1717 City View Street Eugene OR

JOB NO. 21001.00.L

ADDENDUM TWO (2)

30 APRIL 2021

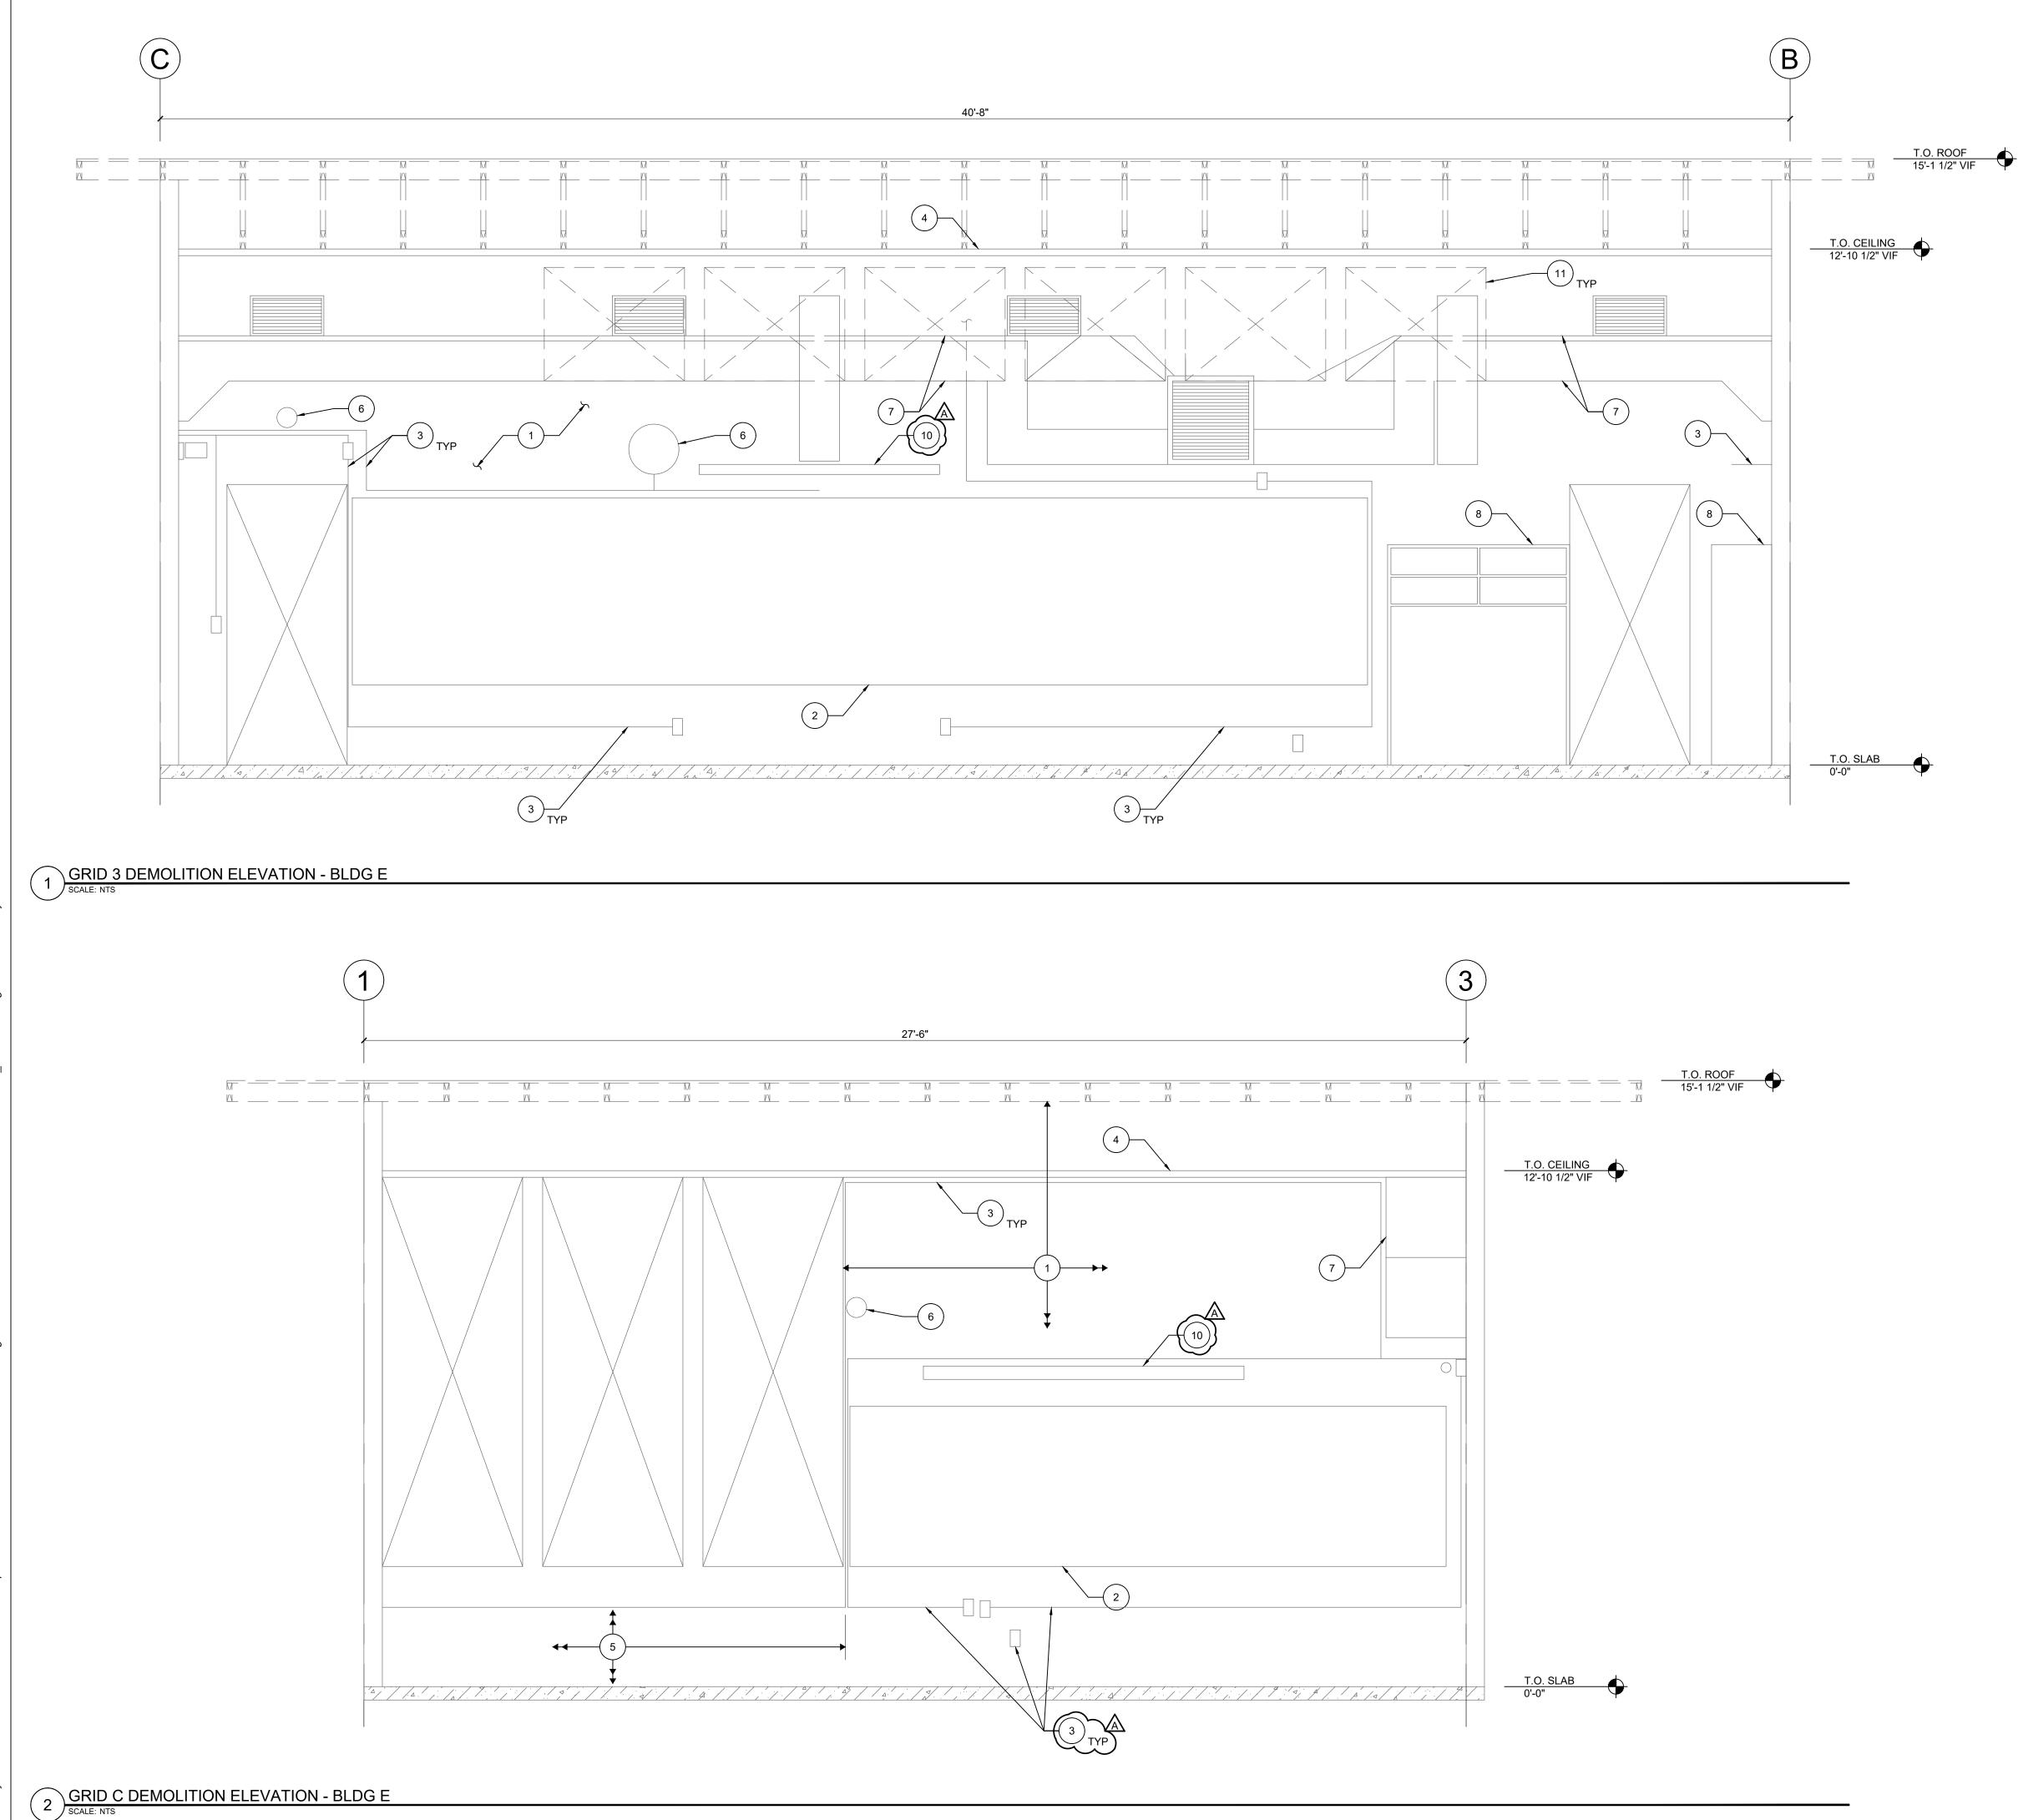
9. Notes 10 on D3.5 and 11 on D3.6 & D3.7 call out demo of window trim and infilling panels. Is there trim to remove in openings shown above the ceilings in details 2/D3.2 and 2/D3.3?

Answer: There is no trim on the infilled window openings shown on 2/D3.2 and 2/D3.3.

CASEWORK ELEVATIONS

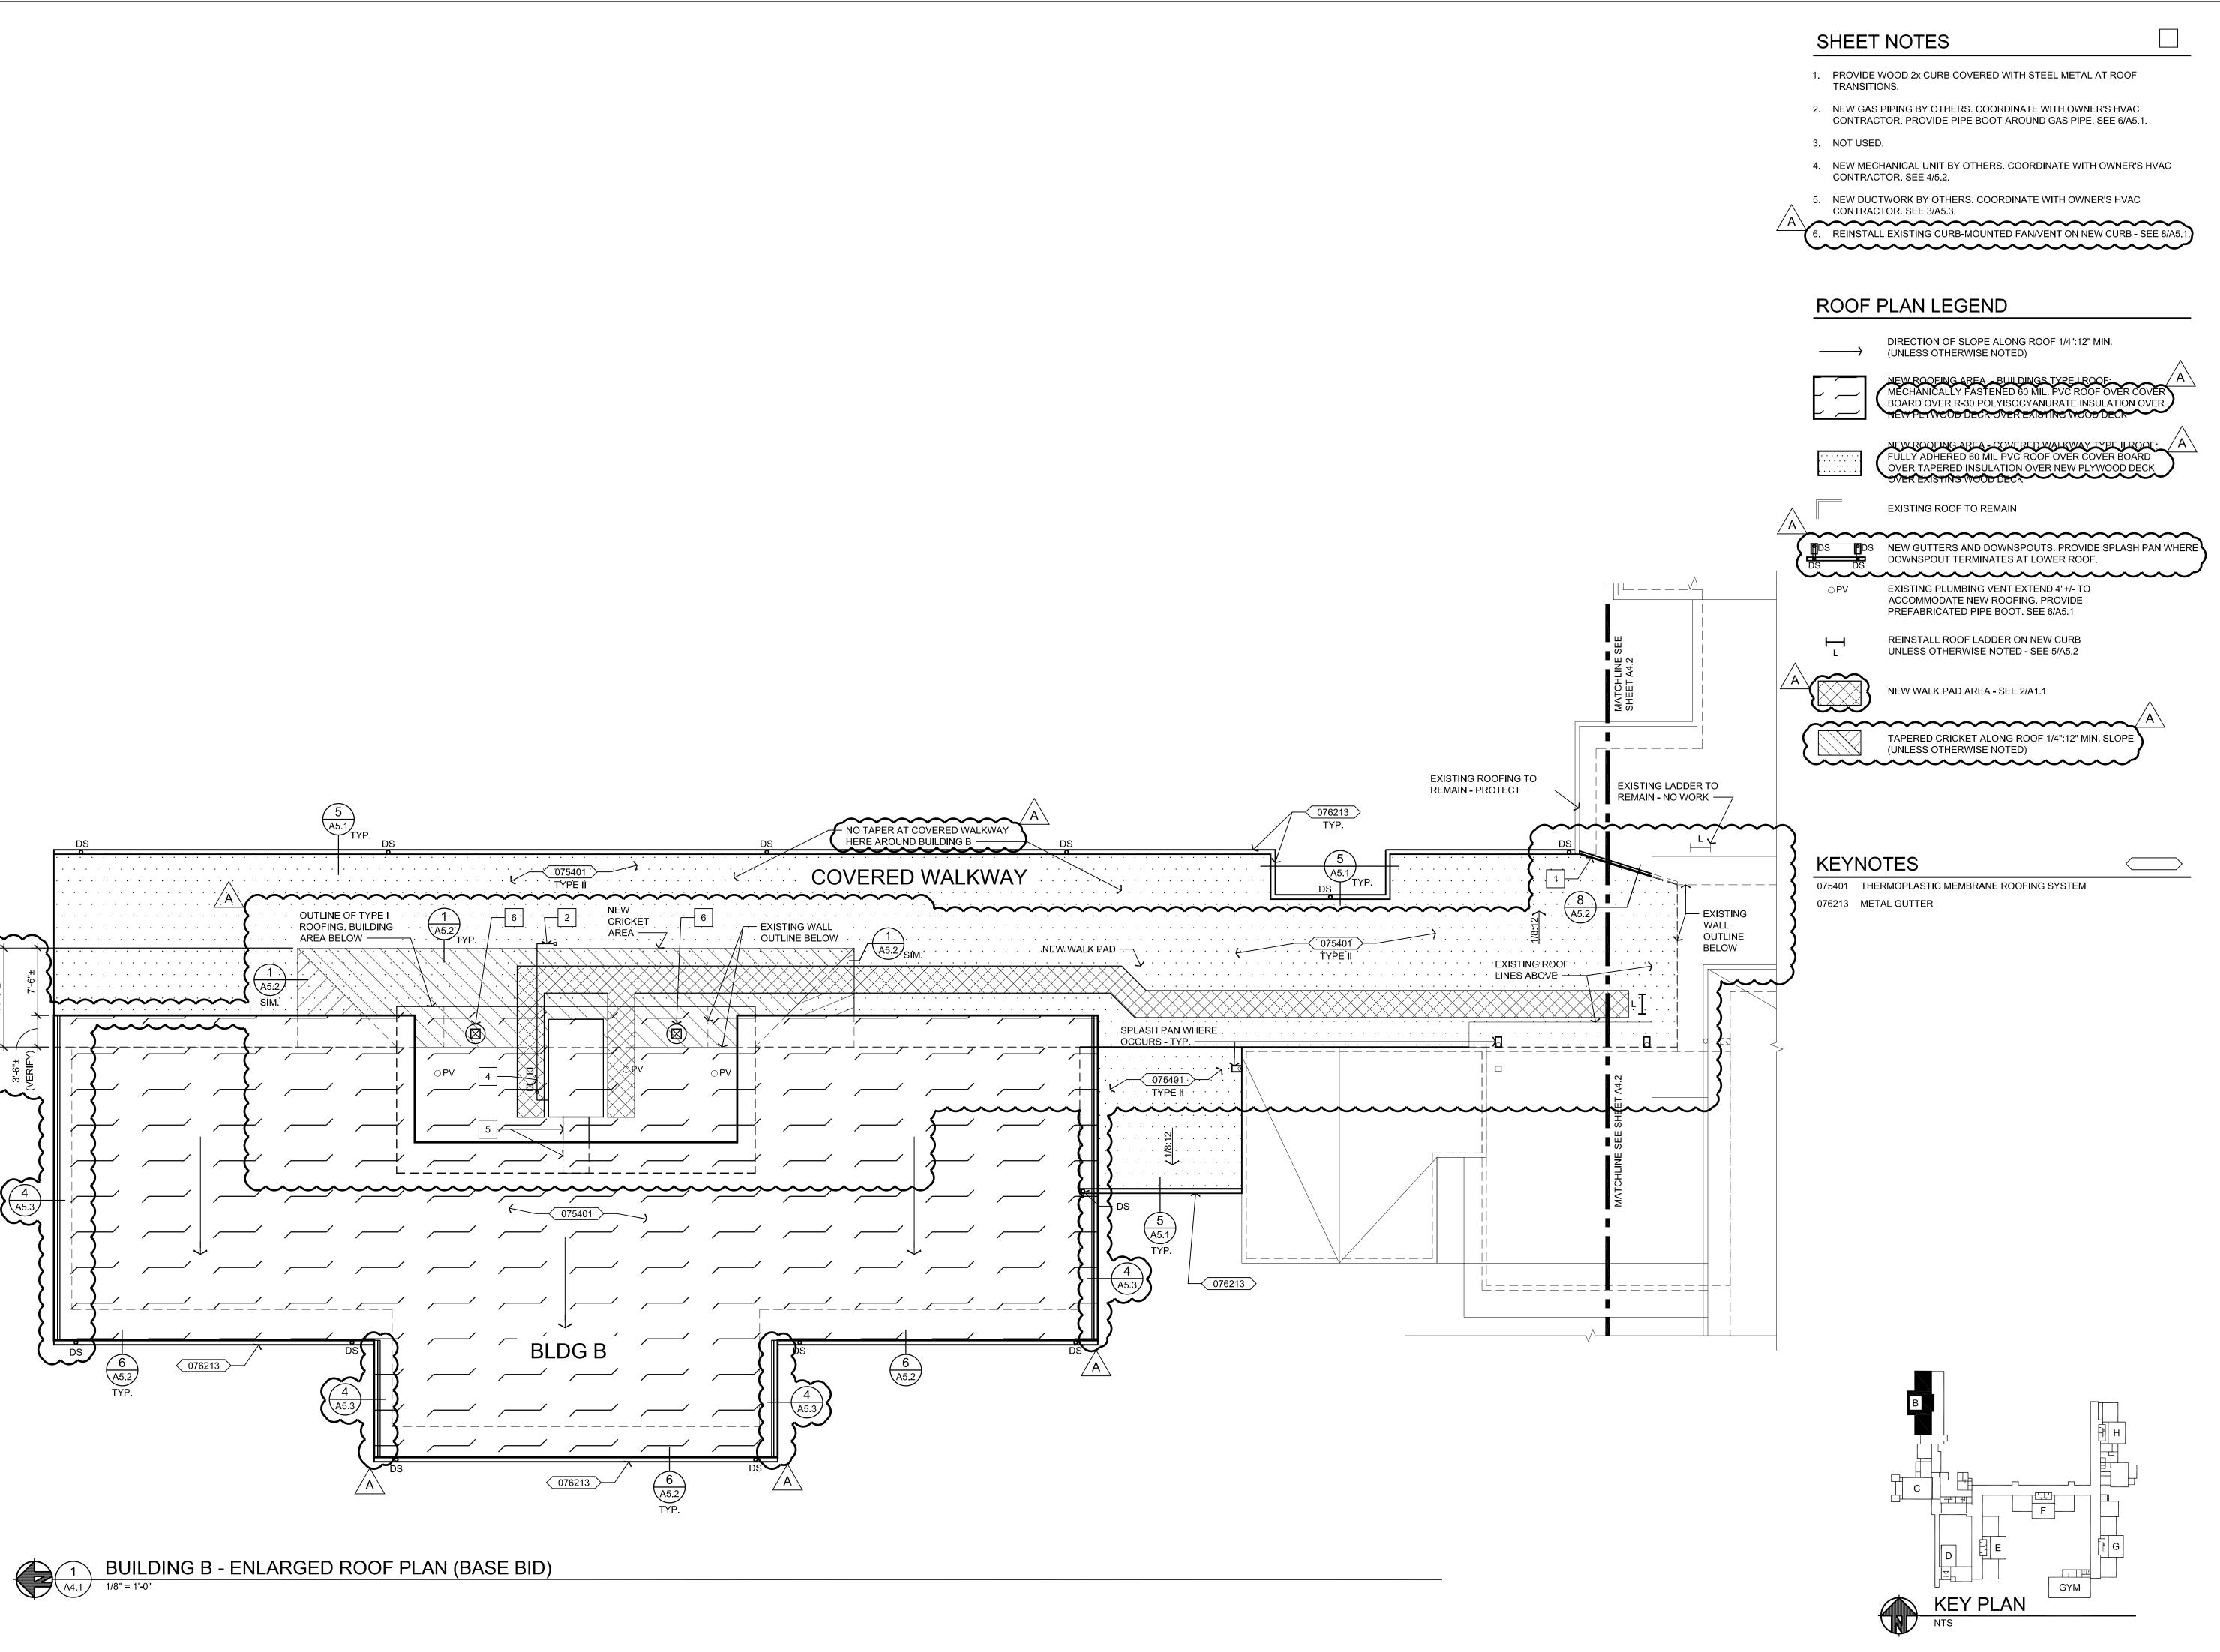
21. For casework that needs to be replaced in kind, please provide elevations for missing areas. Provide details & sections if possible.

Answer: New casework is to be installed in all of the classrooms where shown on the plans
